STAFF REPORT

To: Bixby Planning Commission
From: Erik Enyart, AICP, City Planner 
Date: Friday, February 22, 2013
RE: Report and Recommendations for:
PUD 76 – “Scenic Village Park” – Tanner Consulting, LLC, and
BZ-364 – Tanner Consulting, LLC

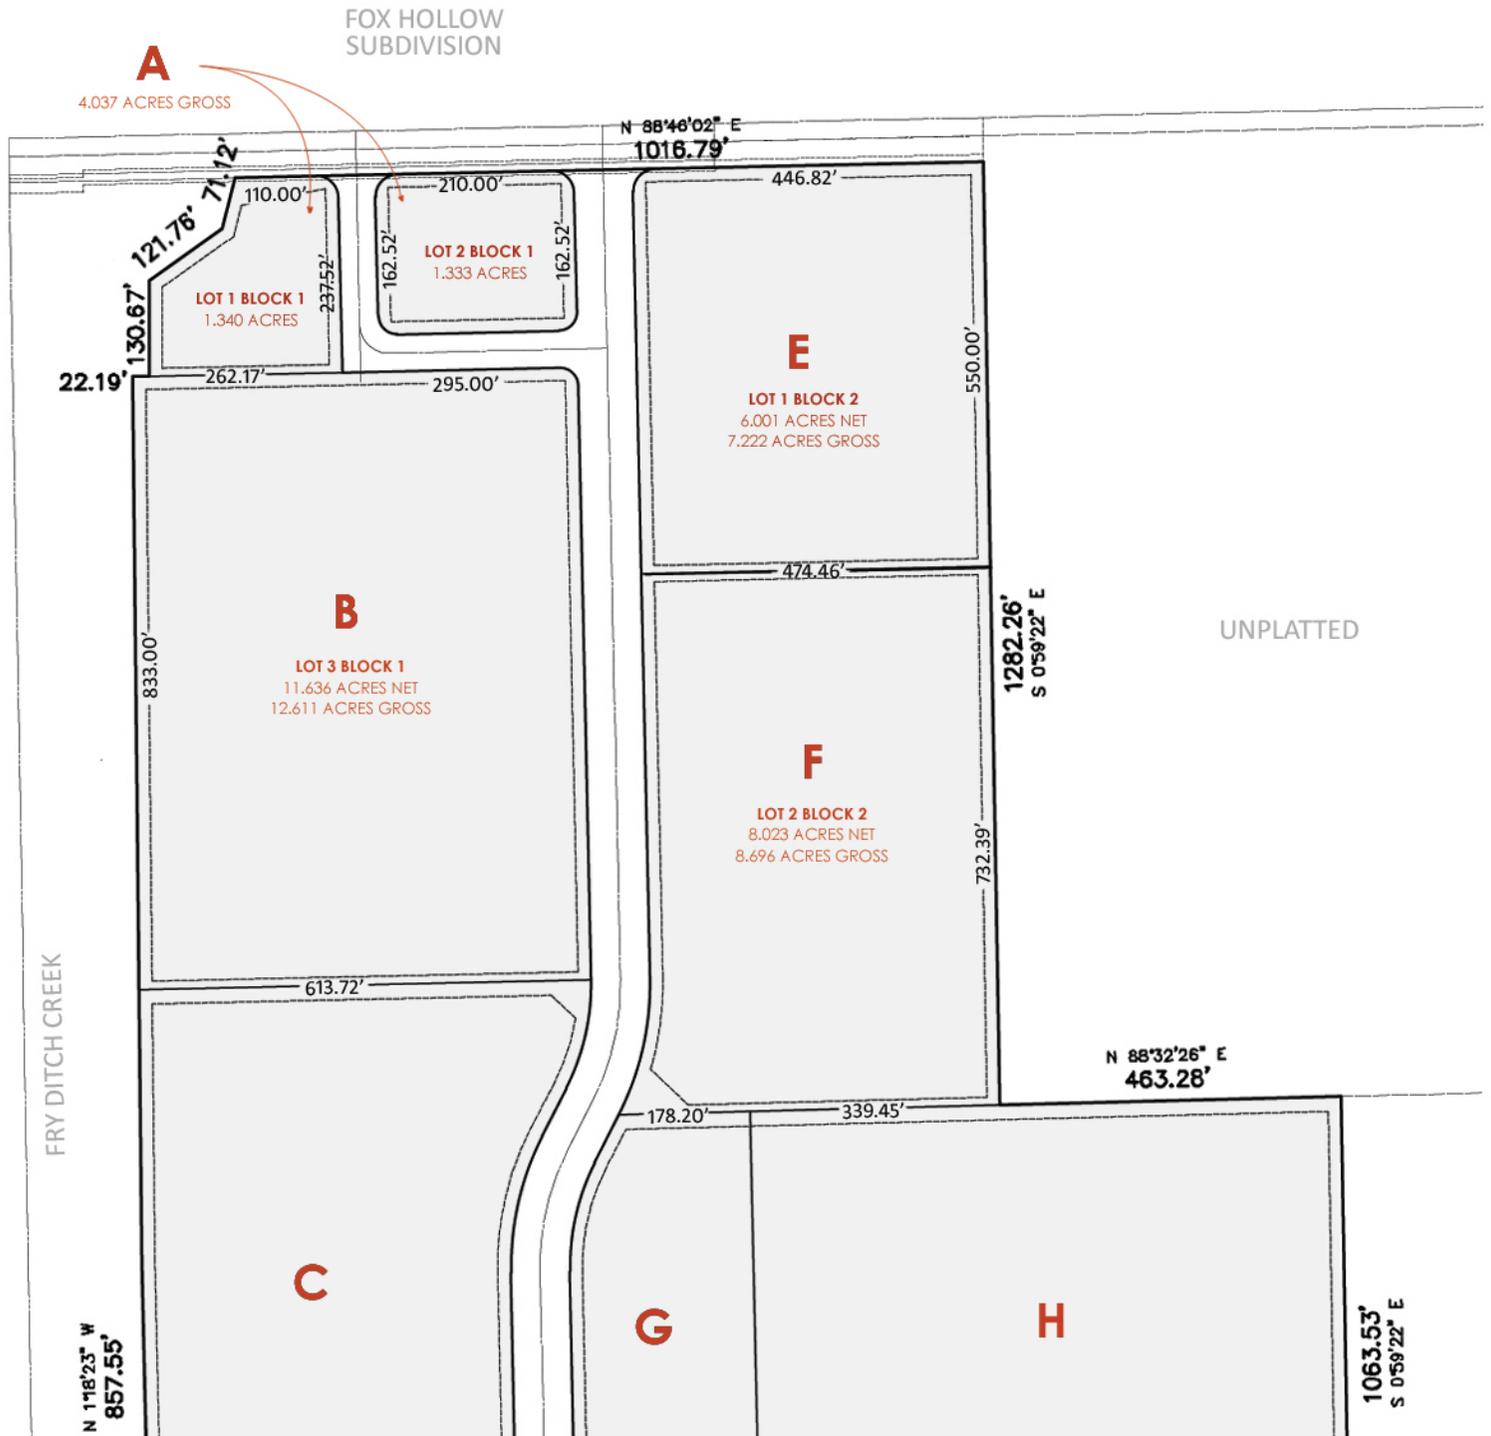
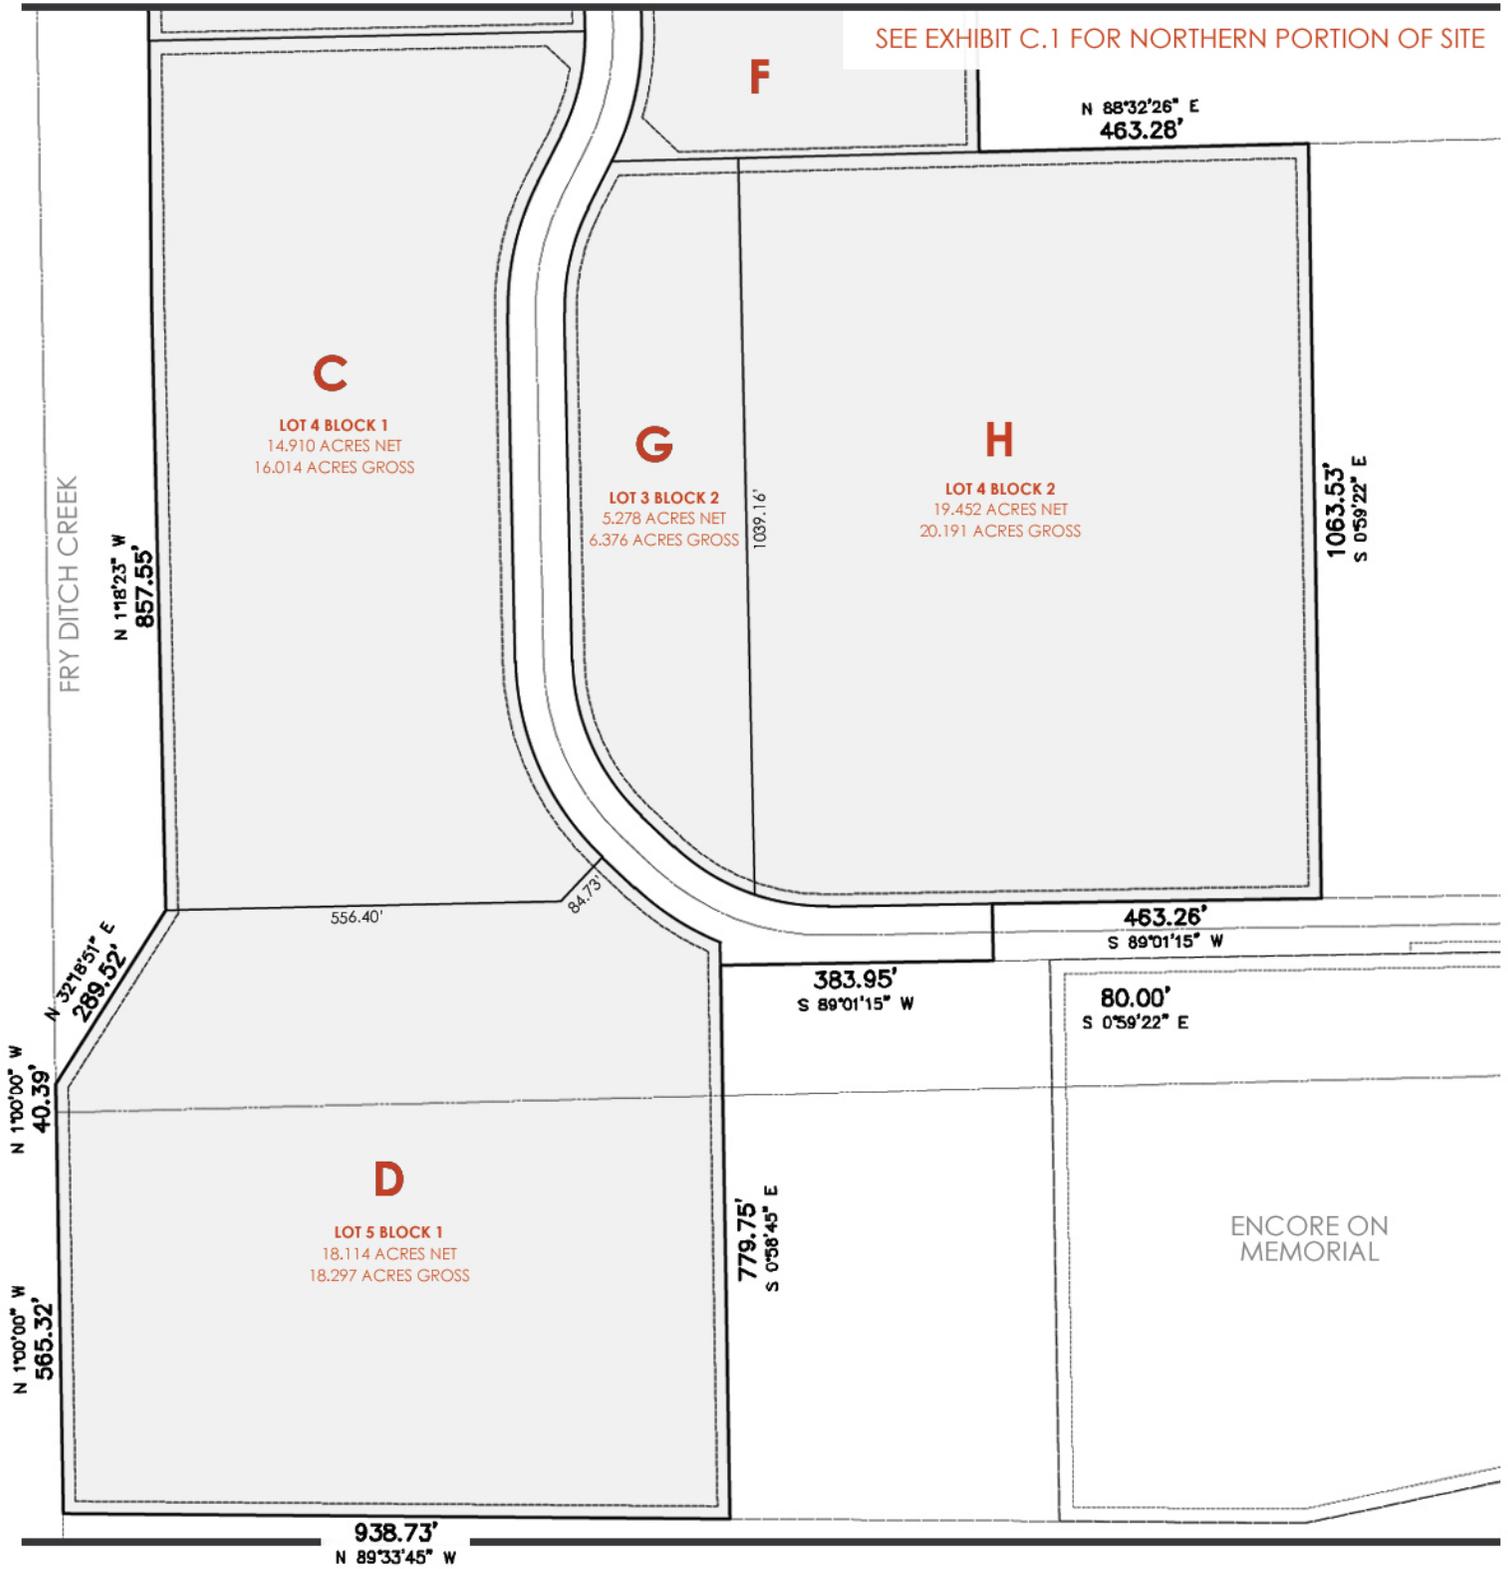
5. Site Plan Exhibits B, C/C.1/C.2, etc.: Please include, represent, identify/label, and/or dimension, or otherwise correct site plan drawings as follows:

- d. Sidewalks
 - e. Fry Creek Ditch access roads on adjoining right-of-way tracts
 - f. Perimeter and/or internal trails (if/as may be planned)
 - g. Development entrance sign if/as may be proposed at 121st St. S.

EXHIBIT F EXISTING AND PROPOSED UTILITY LAYOUT

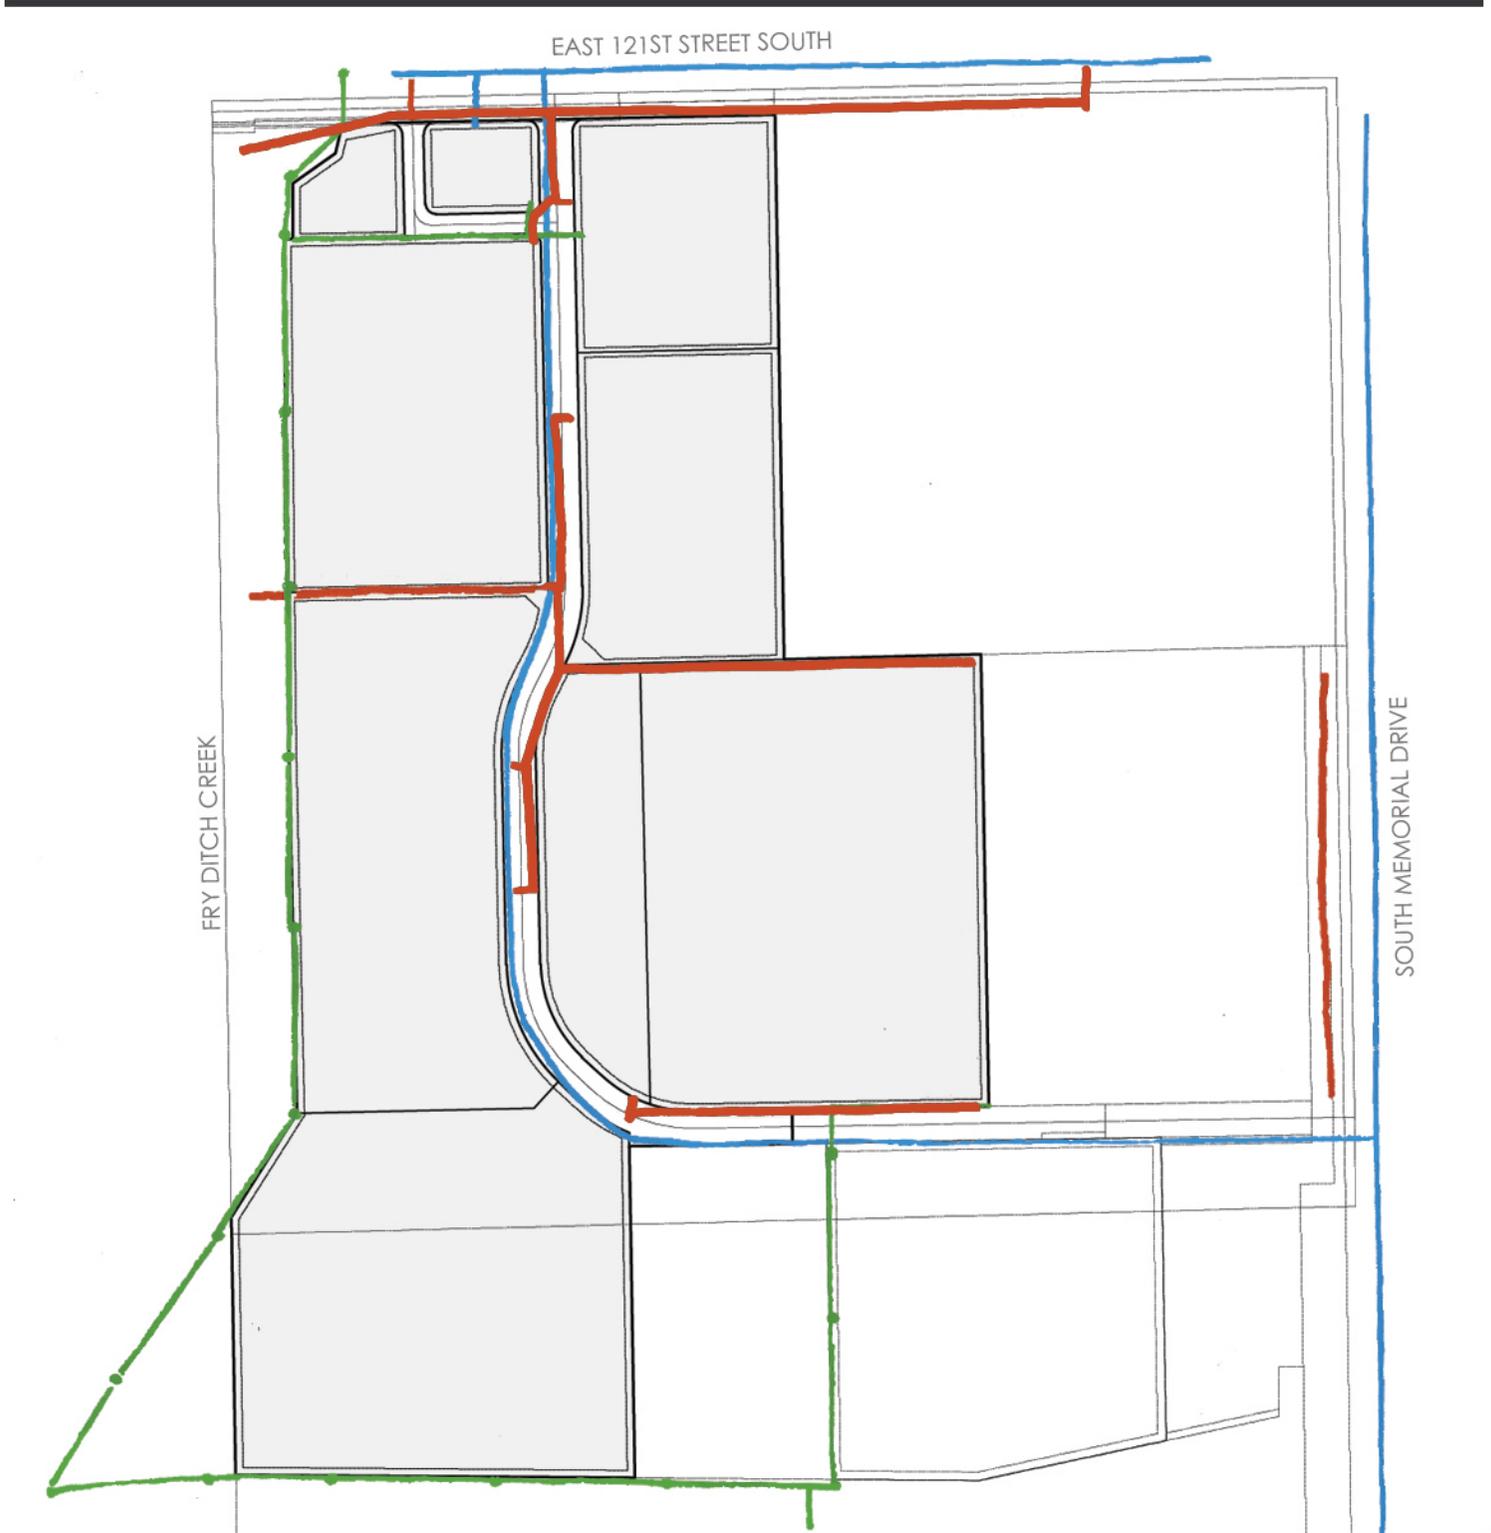
1. An Infrastructure Master Plan for the project will be required that addresses sanitary sewer, storm water, and water systems with the Preliminary Plat.
2. Infrastructure Master Plan will need to include sanitary sewer and storm sewer connections available to off-site properties that are not currently served.
3. The storm sewer system must accommodate runoff from adjacent properties under fully developed conditions. Project development should not inhibit the existing drainage patterns.
4. Fee-in-lieu charges of \$0.20/sf of impervious area are applicable to this area. Detention is not required.
5. A water loop extending service to Lot 1, Block 1 must be provided.
6. Street right-of-way should be of sufficient width to permit future roadway widening and/or turning lanes to serve future development of adjacent tracts.
